**FEMA Levee Certification
Ventura County, California**

**Ventura River Levee and Floodwall (VR-3)
At Live Oaks**

**Evaluation Report
February 13, 2009**

- Exhibit 1 – Field Investigation Report
- Exhibit 2 – Preliminary Evaluation of Levee System Profiles
- Exhibit 3 – As-Built Plans Status List
- Exhibit 4 – Responses to Comments on Draft Evaluation Report

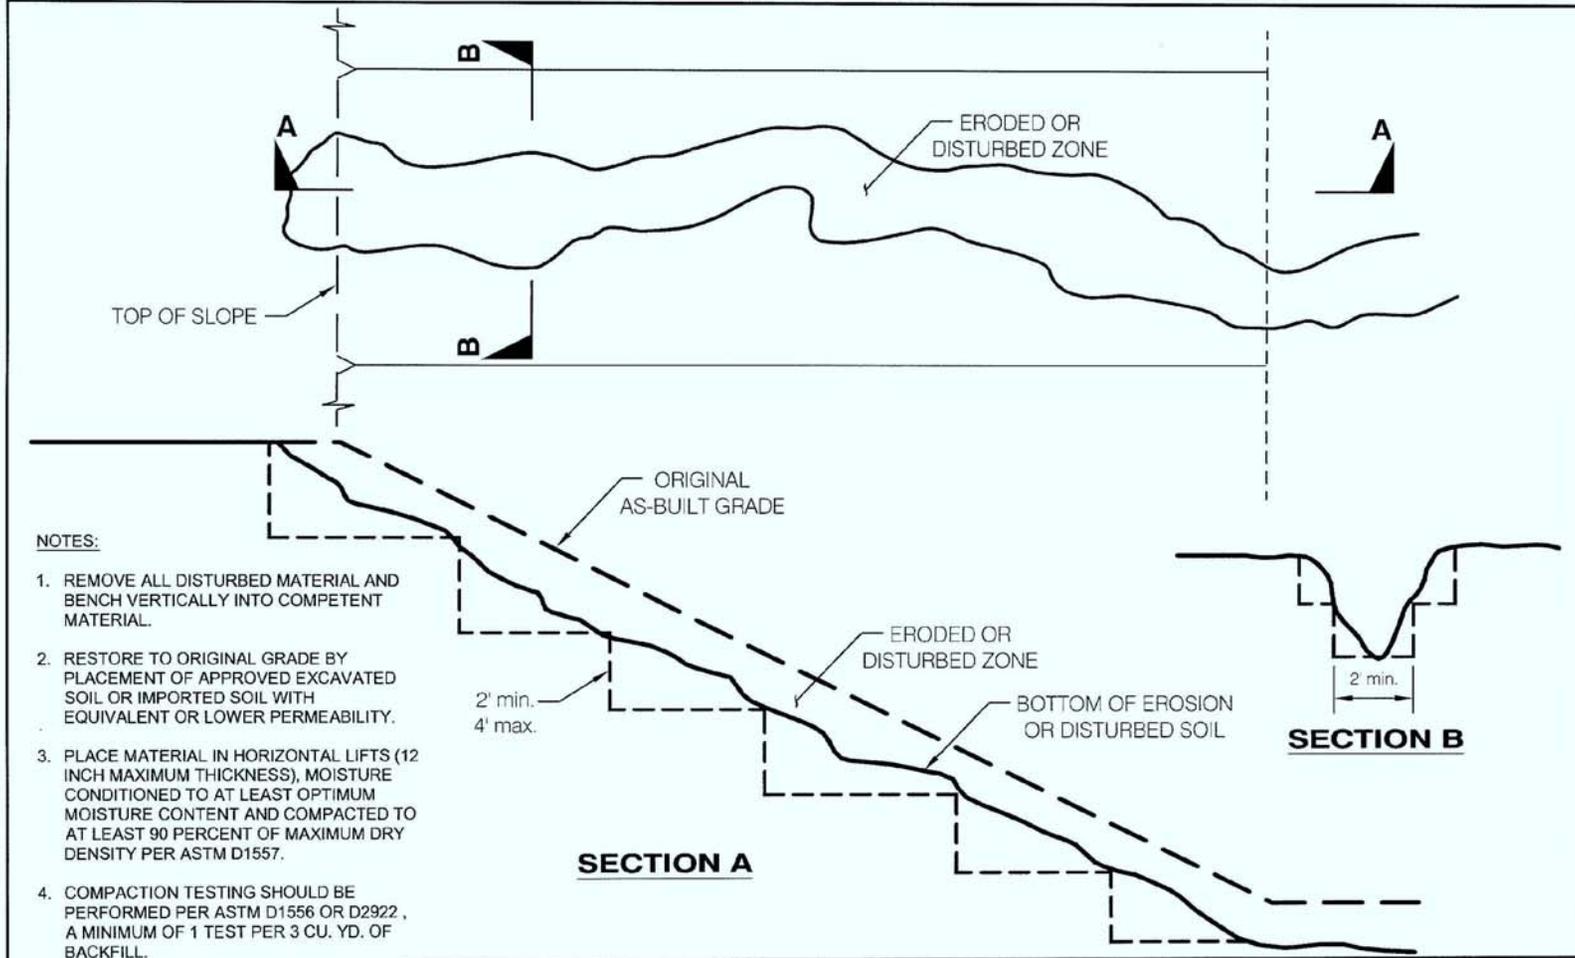
<p>4. Can Tetra Tech provide specs for compaction and grading requirements? Discuss major and minor repair examples.</p>	<p>Compaction requirements are detailed on the attached Figures 1 and 2. Major repair examples include any erosion feature that is deeper than 1 foot or that is greater than 2 feet wide. Major and minor animal burrows are discussed in item 1.</p>
<p>5. Can in-kind materials be used for backfill?</p>	<p>In-kind backfill would be materials free of organic or deleterious debris that has similar or lower permeability than the levee material. These materials could consist of excavated soil, imported soil, concrete, or slurry, and shall be evaluated by the testing and materials lab.</p>
<p>6. Discuss documentation/inspection requirements for verification of grading.</p>	<p>The requirements for verification of grading are discussed above.</p>

1. REMOVE ALL DISTURBED MATERIAL AND BENCH VERTICALLY INTO COMPETENT MATERIAL.
2. RESTORE TO ORIGINAL GRADE BY PLACEMENT OF APPROVED EXCAVATED SOIL OR IMPORTED SOIL WITH EQUIVALENT OR LOWER PERMEABILITY.
3. PLACE MATERIAL IN HORIZONTAL LIFTS (12 INCH MAXIMUM THICKNESS), MOISTURE CONDITIONED TO AT LEAST OPTIMUM MOISTURE CONTENT AND COMPACTED TO AT LEAST 90 PERCENT OF MAXIMUM DRY DENSITY PER ASTM D1557.
4. COMPACTION TESTING SHOULD BE PERFORMED PER ASTM D1556 OR D2922, A MINIMUM OF 1 TEST PER 3 CU. YD. OF BACKFILL.

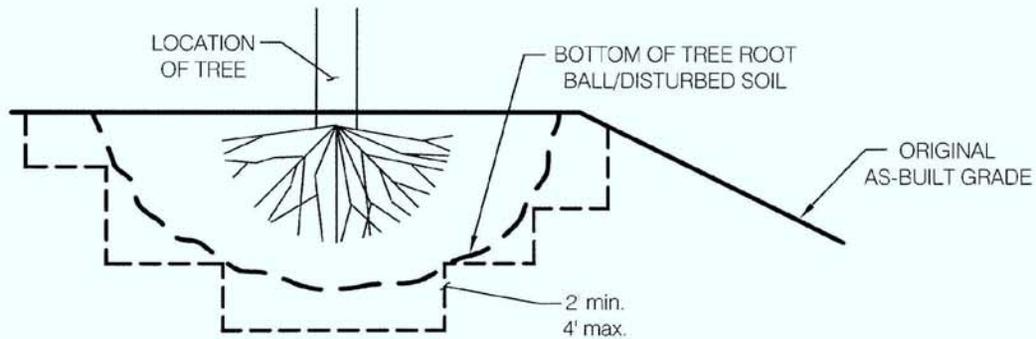
<p>2. Please describe methods for vegetation and rootball removal.</p>	<p>4" DIAMETER TRUNK OR GREATER: Cut the woody vegetation approximately two (2) feet above ground level leaving a prominent stump for use in the rootball extraction process. Remove the stump and rootball by pulling or extracting with a backhoe or similar equipment. Clean the rootball cavity of all loose soil and remaining root system (roots greater than 1/2" diameter). Prepare the cavity by excavating per FIGURE 2. Backfill with excavated soil or imported soil with equivalent or lower permeability. Place material in horizontal lifts no greater than twelve (12) inches. Moisture conditioned to at least optimum moisture content and compacted to at least ninety (90) percent of the maximum dry density of the fill soil per ASTM D1557. Compaction typically requires the use of manually operated compaction equipment or compaction attachment to a backhoe. Compaction testing should be performed per ASTM D1556 or D2922. A minimum of one (1) test per three (3) cubic yards of backfill.</p> <p>2"-4" DIAMETER TRUNK: Cut the woody vegetation stump flush with the ground. Treat the stump with a protective coating similar to polyurethane to prolong the decay process.</p>

1. REMOVE ALL DISTURBED MATERIAL AND BENCH VERTICALLY INTO COMPETENT MATERIAL.
2. RESTORE TO ORIGINAL GRADE BY PLACEMENT OF APPROVED EXCAVATED SOIL OR IMPORTED SOIL WITH EQUIVALENT OR LOWER PERMEABILITY.
3. PLACE MATERIAL IN HORIZONTAL LIFTS (12 INCH MAXIMUM THICKNESS), MOISTURE CONDITIONED TO AT LEAST OPTIMUM MOISTURE CONTENT AND COMPACTED TO AT LEAST 90 PERCENT OF MAXIMUM DRY DENSITY PER ASTM D1557.
4. COMPACTION TESTING SHOULD BE PERFORMED PER ASTM D1556 OR D2922, A MINIMUM OF 1 TEST PER 3 CU. YD. OF BACKFILL.
